SUBJECT: OPERATING CYCLE 11 RELOAD (TSCR 149, TAC 61863)

Re: Oyster Creek Nuclear Generating Station

Amendment No. 111  
License No. DPR-16

SUPPORTING AMENDMENT NO. 111 TO PROVISIONAL OPERATING LICENSE NO. DPR-16

FIGURE 3.10-4  
MAXIMUM ALLOWABLE AVERAGE PLANAR  
LINEAR HEAT GENERATION RATE  
(FIVE LOOP OPERATION)

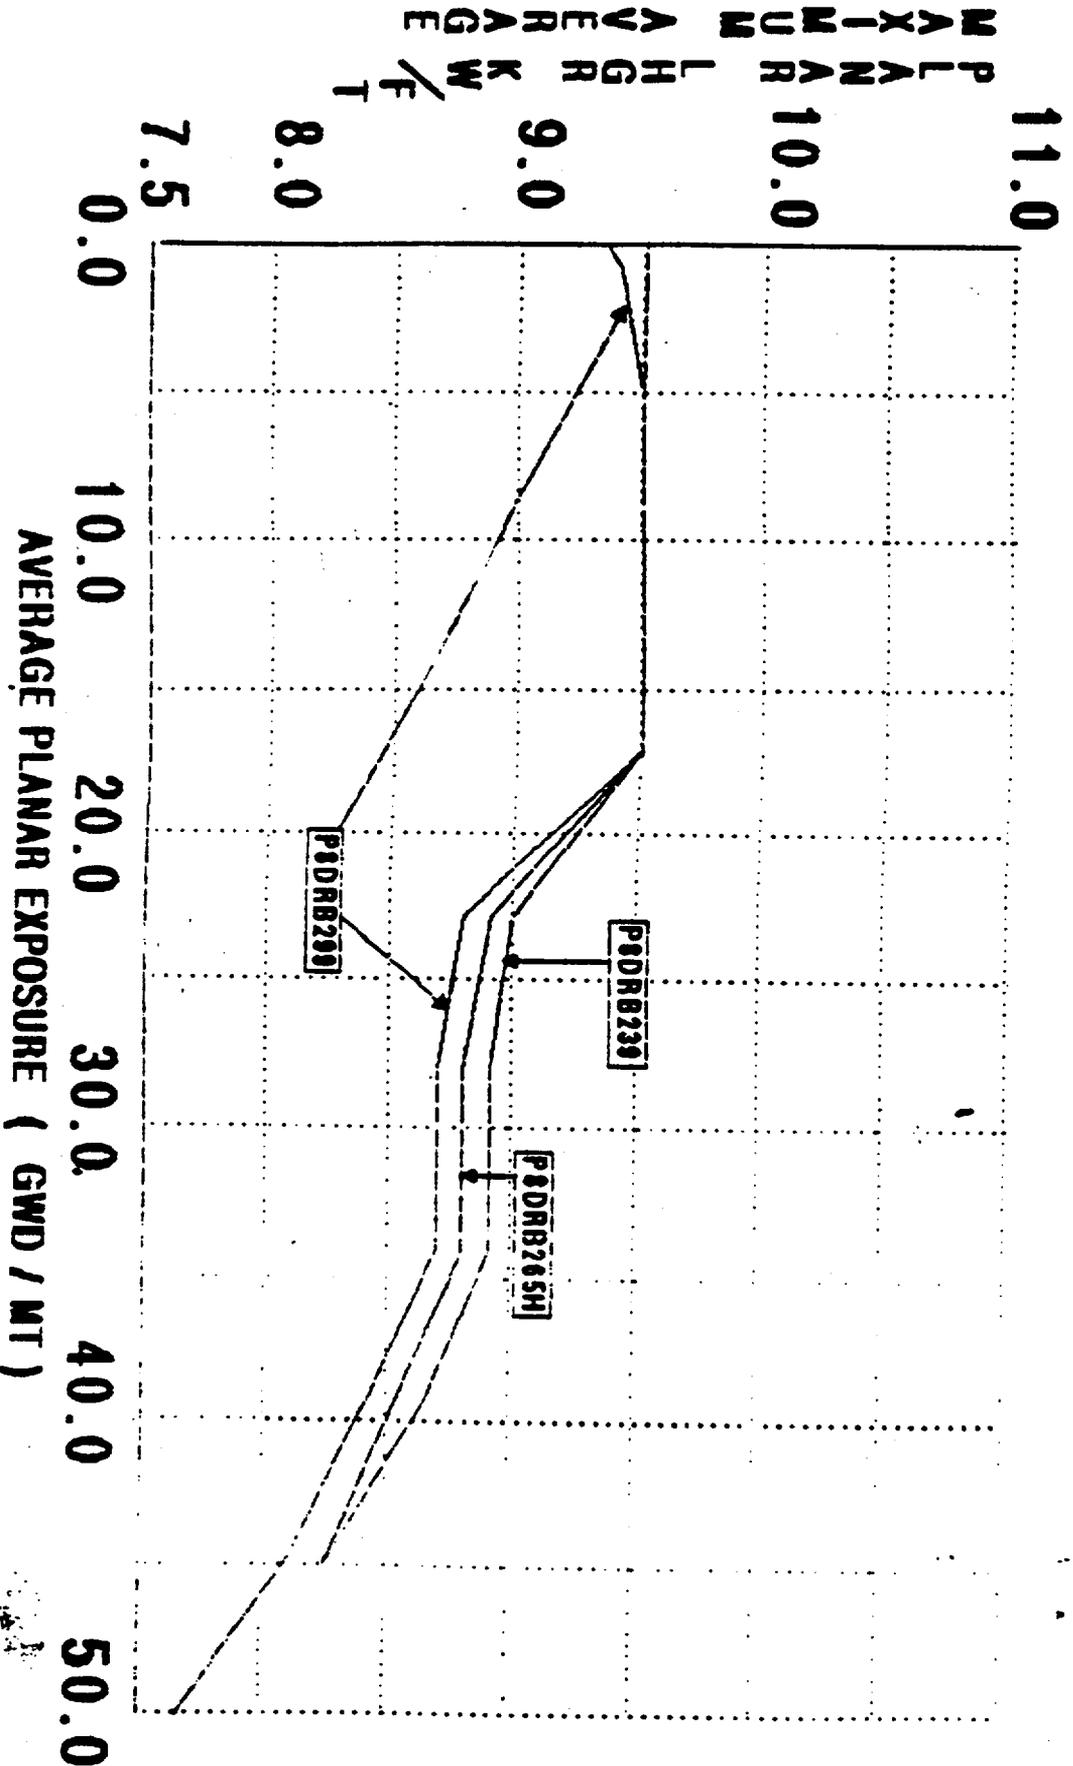
The licensee has proposed that two MAPLHGR curves for the fresh fuel bundles of P8DRB299 be added to the Oyster Creek Technical Specifications to replace a reference to the same curves in a proprietary General Electric Topical Report (Reference 4). This is an administrative change which we find to be acceptable and appropriate.

The MCPR Limits are revised from 1.40 to 1.45 and maximum allowable average planar LHGR curves for 5 and 4 loop operations as described in Appendix D of Reference 1 are added. The staff has reviewed the proposed TS changes for Cycle 11 and concludes that they are acceptable.
